# Residential Appeals Committee

STAFF REPORT

Case File Number: PLN15-152-A01(CP15-012)

<b>Location:</b>	Vacant lot located between 6326 and 6344 Thornhill Drive
<b>Assessor's Parcel Number(s):</b>	048F-7379-006-00
<b>Proposal:</b>	Appeal of Zoning Manager's approval of development application to construct a new single-family dwelling with an Accessory Dwelling Unit (ADU) on an existing vacant upsloping lot; and protect existing watercourse
<b>Appellant:</b>	Jeffrey Kessler (510)339-1701
<b>Applicant:</b>	Robert Wirth (510)459-1010
<b>Owner:</b>	Helen Yu
<b>Case File Number:</b>	PLN15-152-A01 (CP15-012)
<b>Planning Permits Required:</b>	Appeal of Zoning Manager's approval of Regular Design Review including CEQA determination, for construction of a new single-family dwelling with an Accessory Dwelling Unit (ADU) on an existing vacant lot and a driveway bridge over an existing creek; and Category 4 Creek Protection Permit to protect existing watercourse.
<b>General Plan:</b>	Hillside Residential

#### CGS Seismic Hazard Map

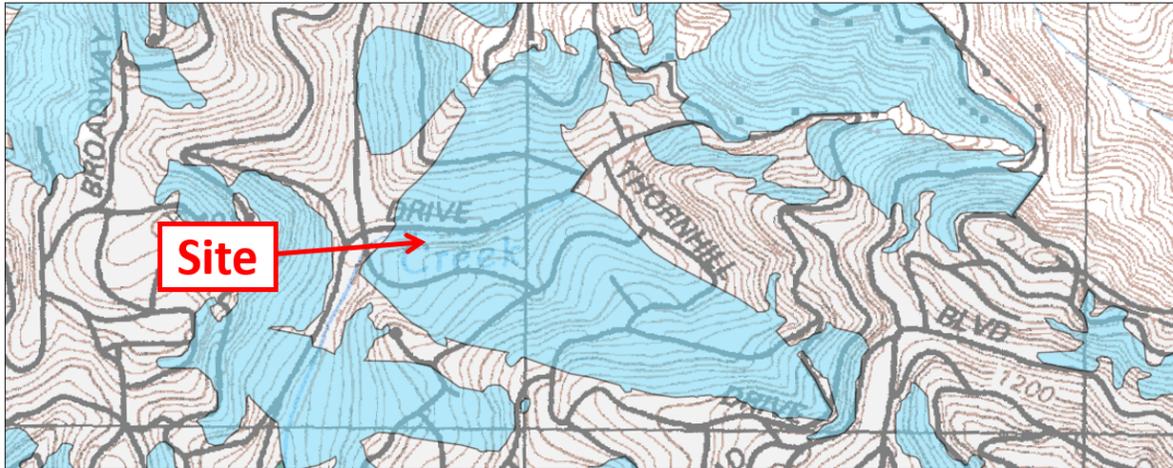
**Comment #2: The Site is within a CGS-mapped Seismic Hazard Zone, which requires a higher degree of investigative diligence than what is reflected in the Geotechnical Investigation Report.**

The official State of California seismic hazard map (below) shows the site within a "zone of required investigation" for earthquake-induced landsliding. CGS Special Publication 117A (SP117A), titled "*Guidelines for Evaluating and Mitigating Seismic Hazards in California*", applies to the preparation and local agency review of geotechnical investigation reports for proposed projects within CGS-mapped Seismic Hazard Zones.

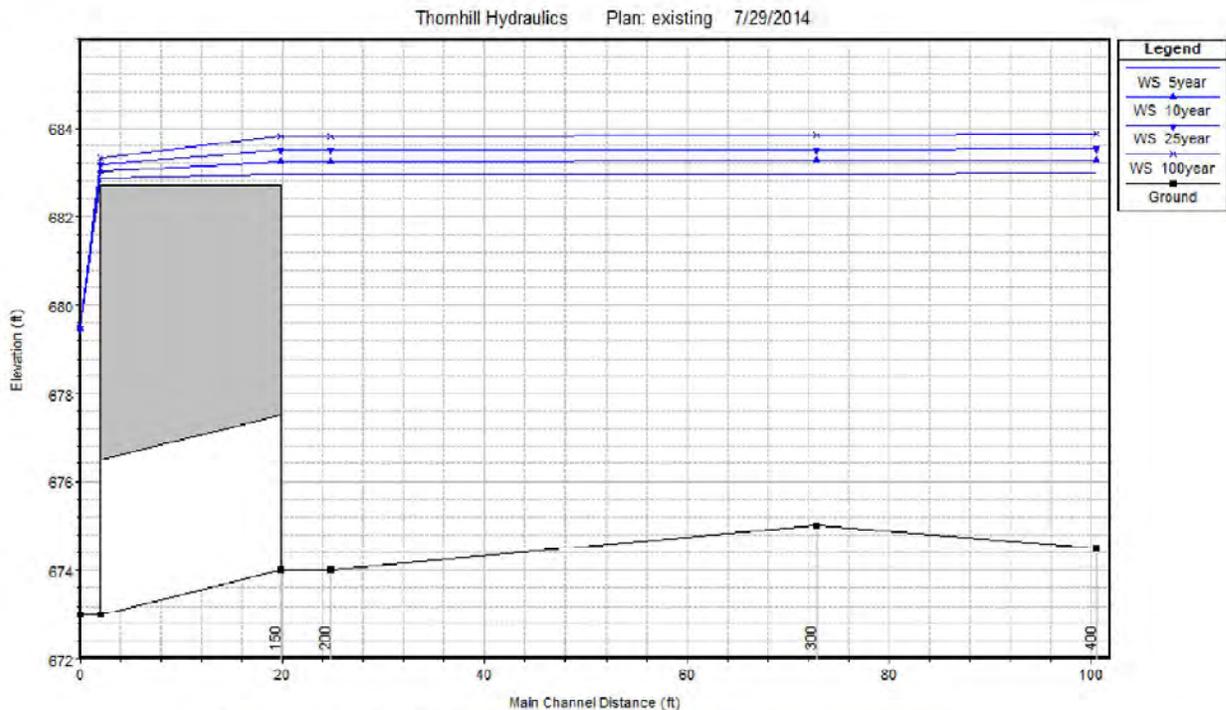
Based on the more accurate independent computation of the tailwater condition, the actual flood level at the 6326 driveway during the 5-yr. flood would unlikely get anywhere near that depicted in Figure 4 for the 5-yr. event, which was predicted to overtop the driveway. The 100-yr. event could overtop the driveway, but further simulations would be required to more accurately confirm the floodflow behavior for that event. Note that the neighbors opposite the project site on the other side of Thornhill Drive (Larry and Sharon Yale) reported that they had never witnessed flow over the driveway at 6326 Thornhill during the 50 yrs. they’ve resided at their address. This would encompass both the 1982, 1997 and 1998 floods, the most likely to have approached the 100-yr. event. As noted in the BH Report, some upstream discharge could be

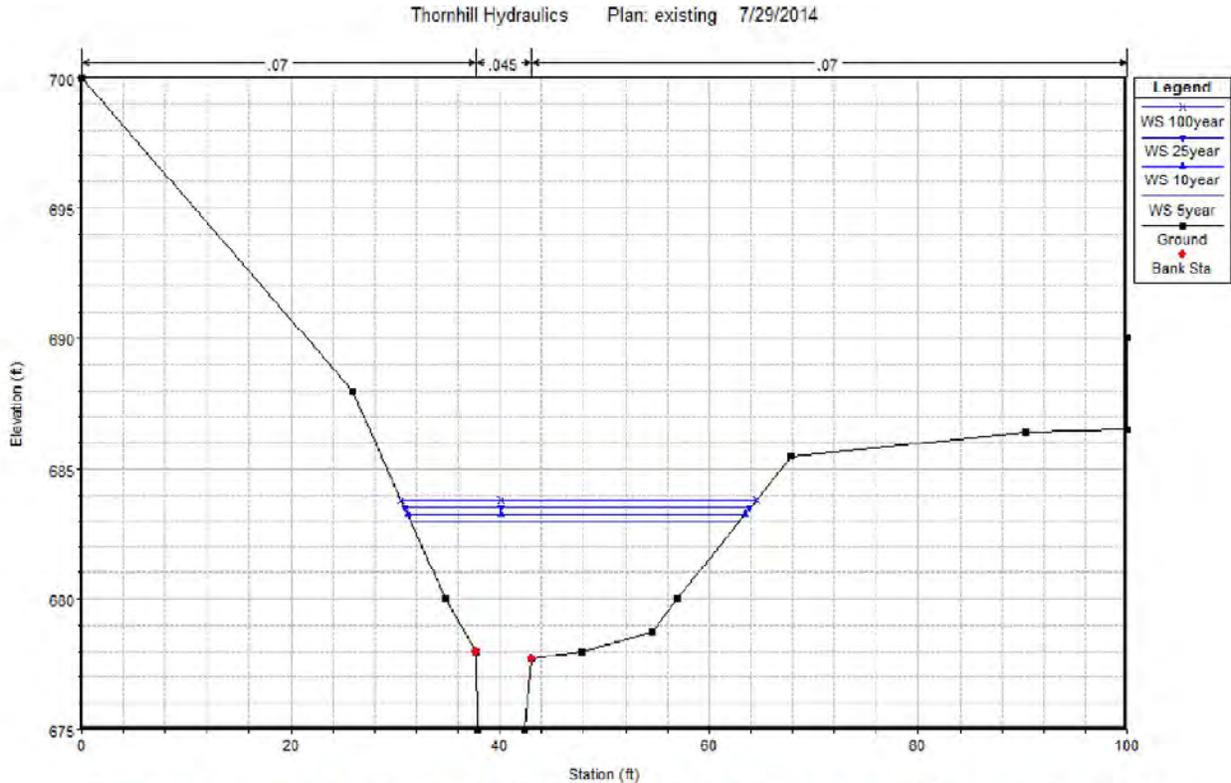
The assertion by CH substantially misrepresents the BH modeling. Specifically, BH explicitly states that a topographic survey was prepared (see second bullet on page 6 of the BH report) and the survey results were provided in Attachment B of the BH report. The single cross section that CH refers to was shown in Figure 5 of the BH

report. However, BH states that Figure 5 shows “the cross section most applicable to the project location” (page 9), not that it was the only cross section considered.
